## SERVICE BULLETIN

ENGINE - AIR - REVISE THE ORIENTATION OF CLIPPING POINT CP5560 - CATEGORY CODE 7, 6 -  
MOD.ENG-75-0035

V2500-ENG-75-0035

Location of the harness bracket and clipping point CP5560  
Fig.1

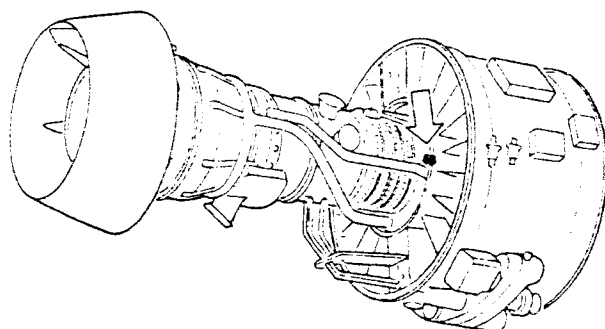
REMOVE  
5W1086  
WASHER

REMOVE 4W0103 BOLT AND  
INSTALL 4W0102 BOLT

REMOVE 5W2153 HARNESS BRACKET AND  
INSTALL 6A5650 HARNESS BRACKET

REMOVE AS21017 BOLTS (2 off) AND  
INSTALL 4W0178 BOLTS (2 off)

View on arrow AA (see Figure 2) - Before alteration  
Fig.3

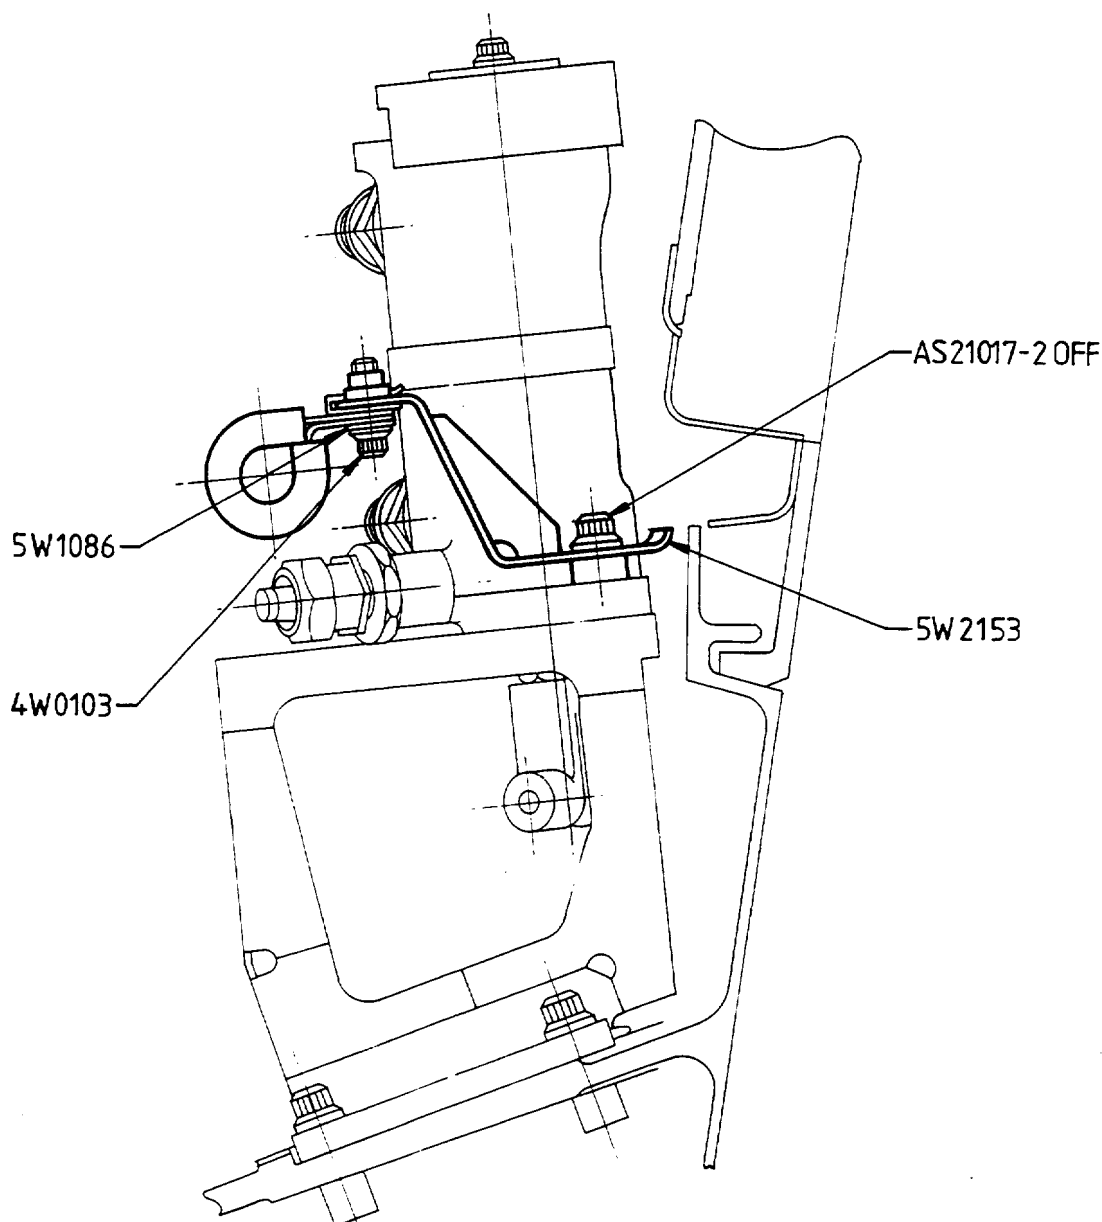
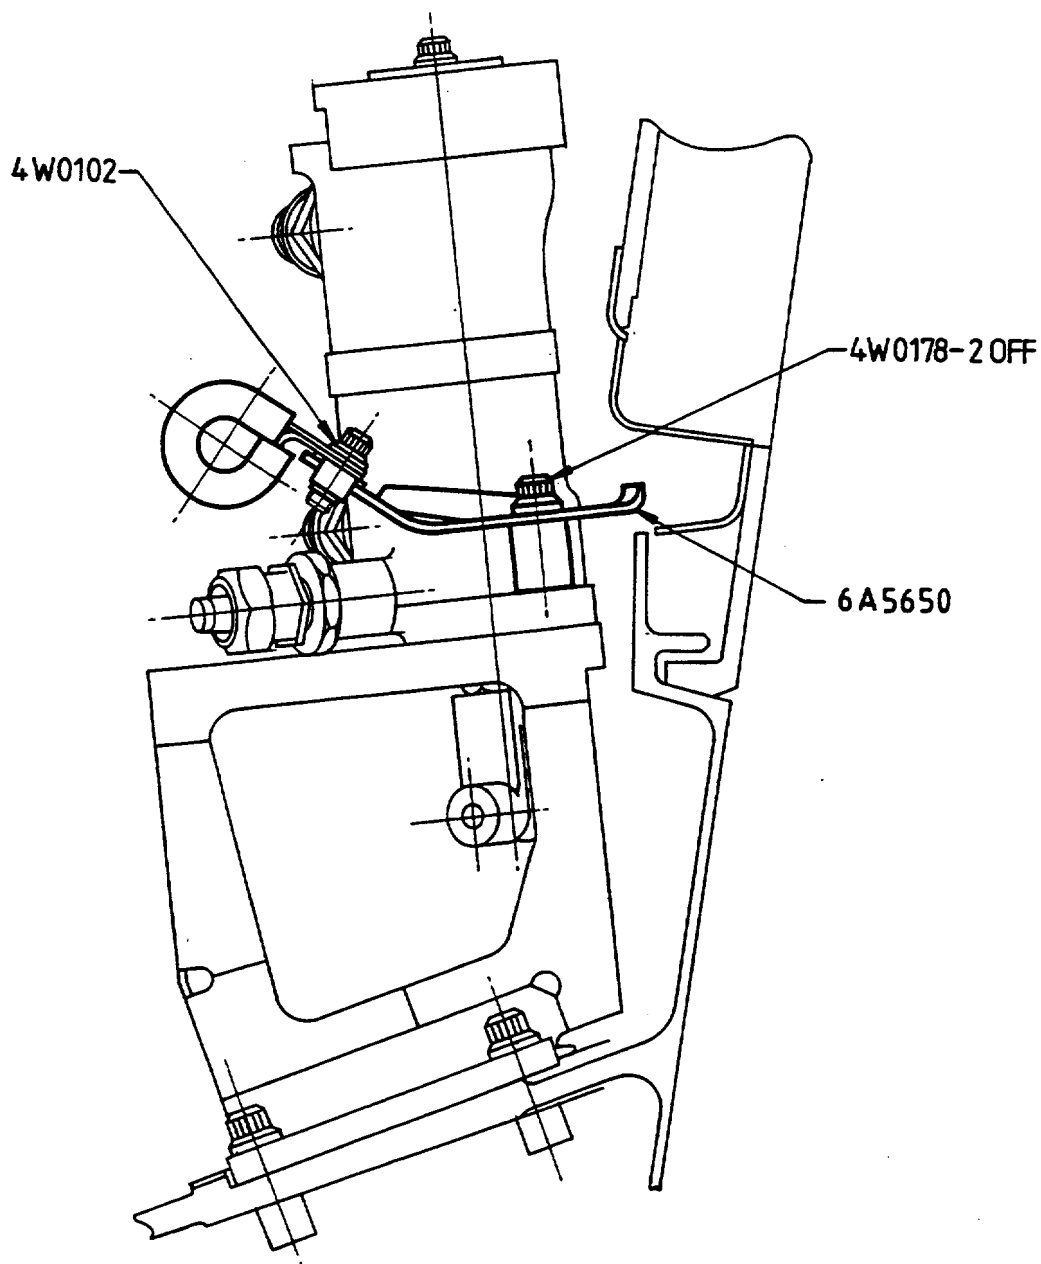
- (1) A new support bracket is introduced to replace the existing bracket mounted from the B.S.B.V. slave actuator for EEC harness clipping point CP5560.
- (2) The washer at the clipping point is deleted and a shorter bolt is introduced to suit.
- (3) To maintain commonisation of manufacture, the modified bracket is also introduced on the A1 model.

- (1) Remove the bolt, the nut and the washer from clipping point CP5560. Refer to Figure 3.
- (2) Remove the two bolts that attach the 5W2153 harness bracket to the B.S.B.V. slave actuator. Remove the bracket. Refer to Figure 3.
- (3) Install the new 6A5650 harness bracket on to the B.S.B.V. slave actuator using the two new 4W0178 bolts. Torque the bolts to 85 to 105 lbfin (10 to 12 Nm). Refer to Figure 4.
- (4) Assemble clipping point CP5560 using the nut removed in step B.(1) and the new 4W0102 bolt (do not install the washer removed in step B.(1)). Torque the bolt to 36 to 45 lbfin (4 to 5 Nm). Refer to Figure 4.
